The X-178

and Eversource's treatments of the A-126, H-123, H-141, K-174, L-163 and A-152

To Eversource, ISO and the PAC,

April 26, 2024

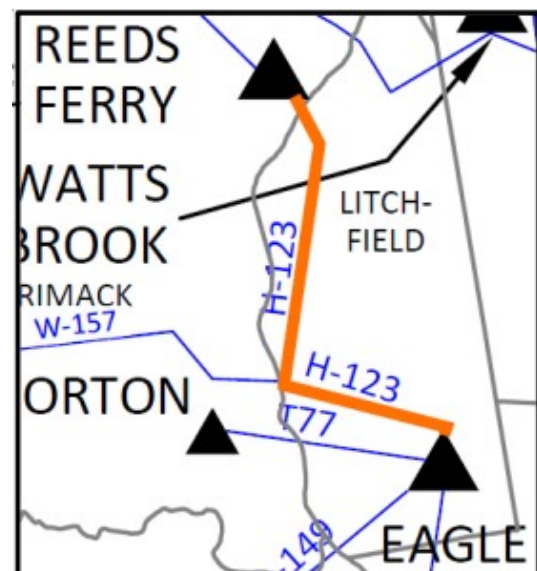
The map (lower right) for this project and the 2018 PAC map (right) both differ from Eversource's transmission maps: It looks like Thorton is mislabeled and is actually Eagle. What is the SS labeled Eagle? The W-157 is shown as connecting to the H-123, which it does, but the H-123 does not, at that point, make a 90 degree turn and head east, according to the Eversource line map below. Watts Brook is a switching station, yet appears to be labeled as a substation.

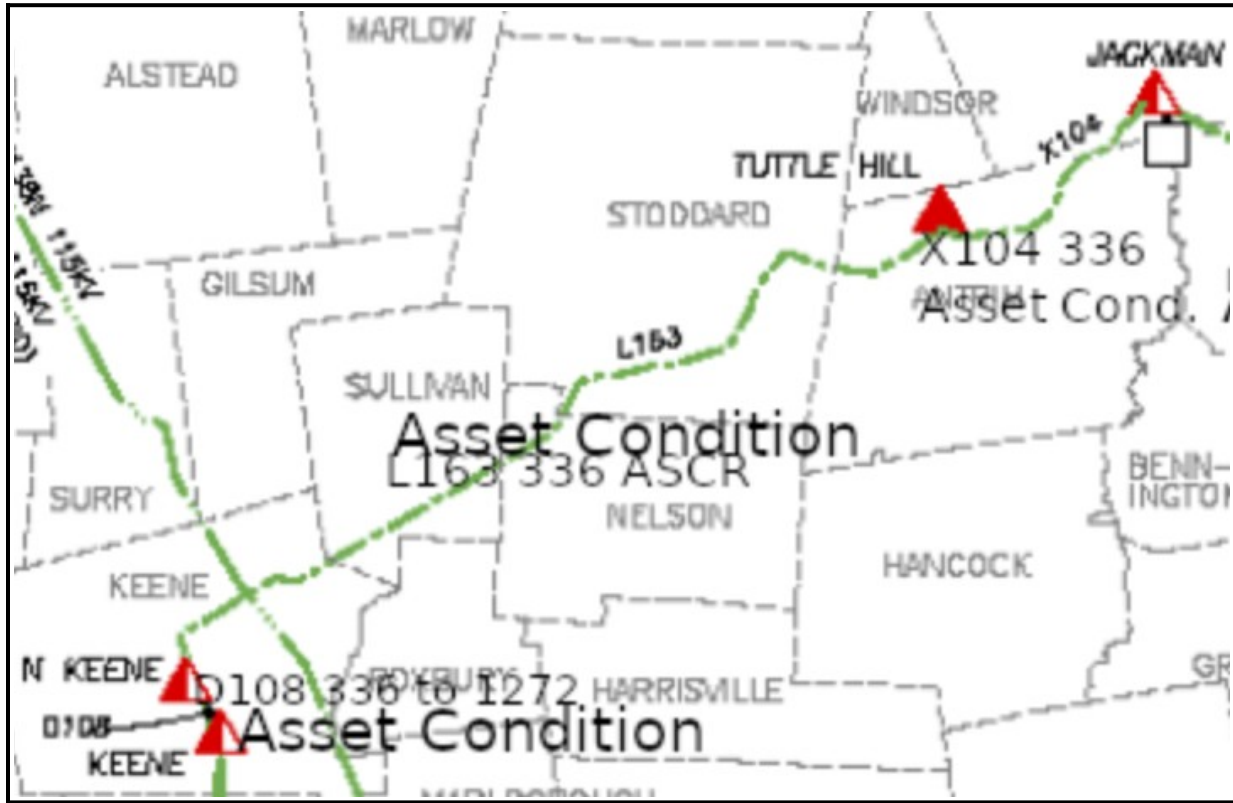
The 2/8/2021 K-174 crossing petition for the North Branch of the Sugar River in Croydon, State owned land in Croydon and Newport, and state owned land in Claremont showed an average structure height increase of 13', consistent with the 12.5' average increase Eversource claims for its proposed the X-178 rebuild and the majority of Eversource's batch-rebuilds and complete rebuilds of its 115kV lines for 1272 ACSS conductor and OPGW.

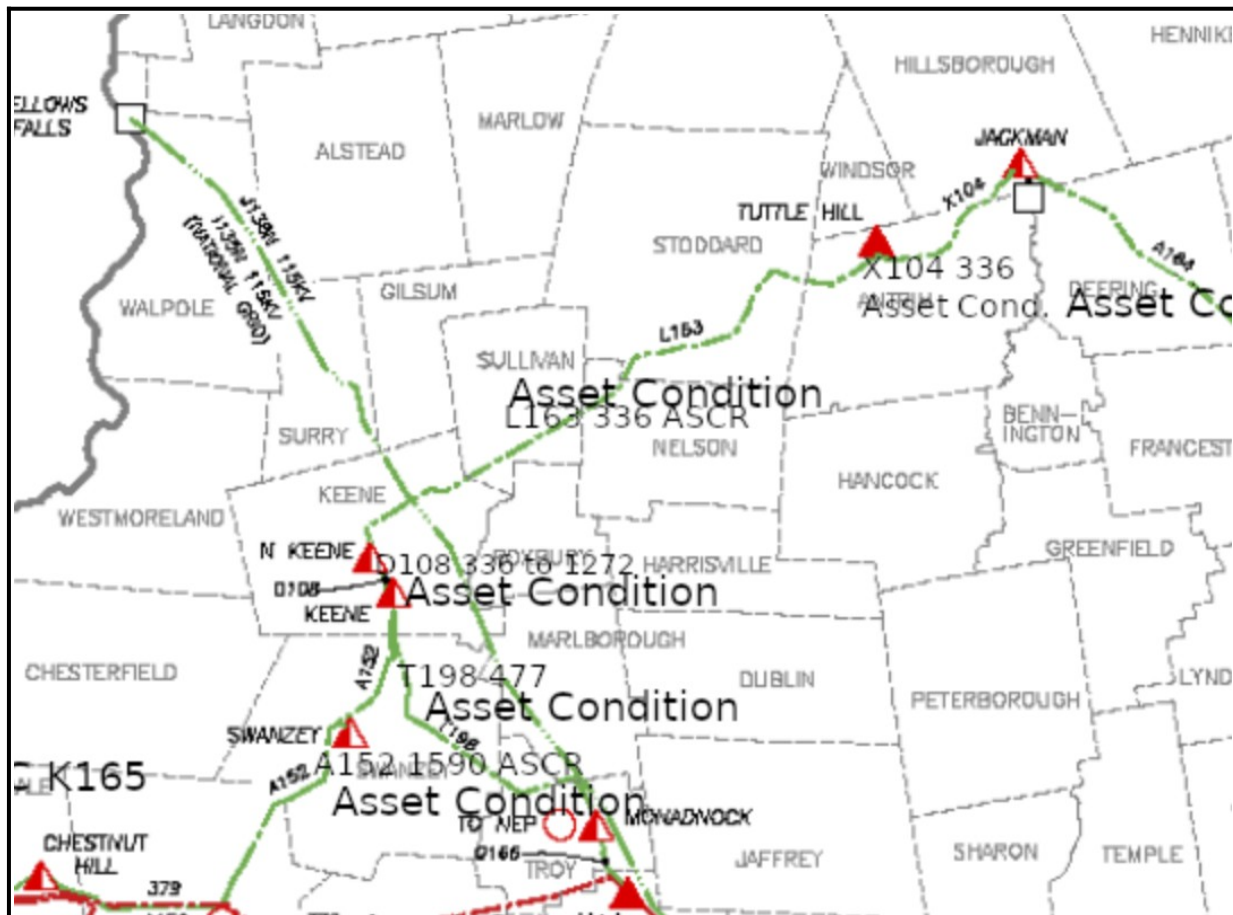
The map in this presentation includes the X-104 and D-108 lines, which were not among the proposed projects. (below right)
